UNITED STATES PATENT AND TRADEMARK OFFICE

APPLICATION NO.	FILING DATE	FIRST NAMED INVENTOR	ATTORNEY DOCKET NO.	CONFIRMATION NO.
10/594,947	09/29/2006	Tadamasa Tsushima	074418-0155	5765
22428	7590	08/26/2009	EXAMINER	
FOLEY AND LARDNER LLP			FREEDMAN, LAURA	
SUITE 500				
3000 K STREET NW			ART UNIT	PAPER NUMBER
WASHINGTON, DC 20007			3616	
			MAIL DATE	DELIVERY MODE
			08/26/2009	PAPER

DETAILED ACTION

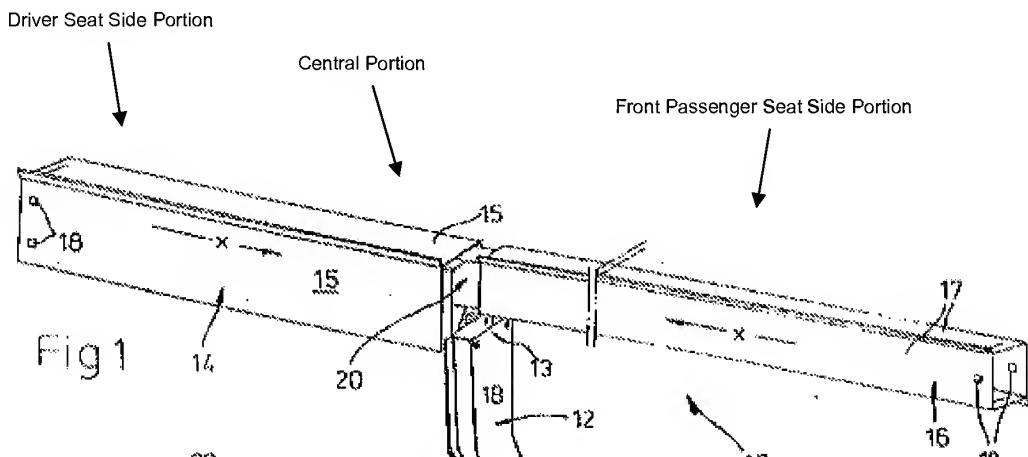
- The steering support member body being divided into a first member (for example, including #14) having a driver seat side portion (for example, including left portion of #14 in figure 1; can be seen in marked-up drawing below) and a central portion (for example, including right portion of #14 in figure 1; can be seen in marked-up drawing below), and a second member (for example, including #16) having a front passenger seat side portion (for example, including some portion of #16, or #16 in its entirety; can be seen in marked-up drawing below)

- Dividing portion (for example, including portion where #14 connects to #16) of the steering support member body is provided with a connecting portion (for example, including #20) comprising a box-shaped insertion portion (for example, including #22) and a receiving portion (for example, including receiving portion formed within walls #17 of second member #16) into which the insertion portion is to be engaged substantially in the vehicle width direction (for example, can be seen in figures 1, 2)

- The receiving portion comprises a stopper face (for example, including surface #16 abuts at its outer end, such as end cap, pillar, door, or similar component) at a deep portion thereof

- The stopper face being configured to restrict an engaged amount of the insertion portion (for example, the surface #16 abuts at its outer end, such as end cap, pillar, door, or similar component, would restrict an engaged amount of the insertion portion #22)
- The insertion portion comprises a stepped portion (for example, including frame #30) lockable (for example, frame #30 prevents movement of #22 within #16 beyond the extent where edge of #16 would abut a surface of #30; can be seen in figures 1, 2) at an inlet portion (for example, including portion of #16 that initially receives #22, as shown in figure 2) of the receiving portion in a fitting direction (for example, including direction "x")
- The stopper face and the stepped portion enable insertion fitting (including paragraphs 001-008, 0022-0026).
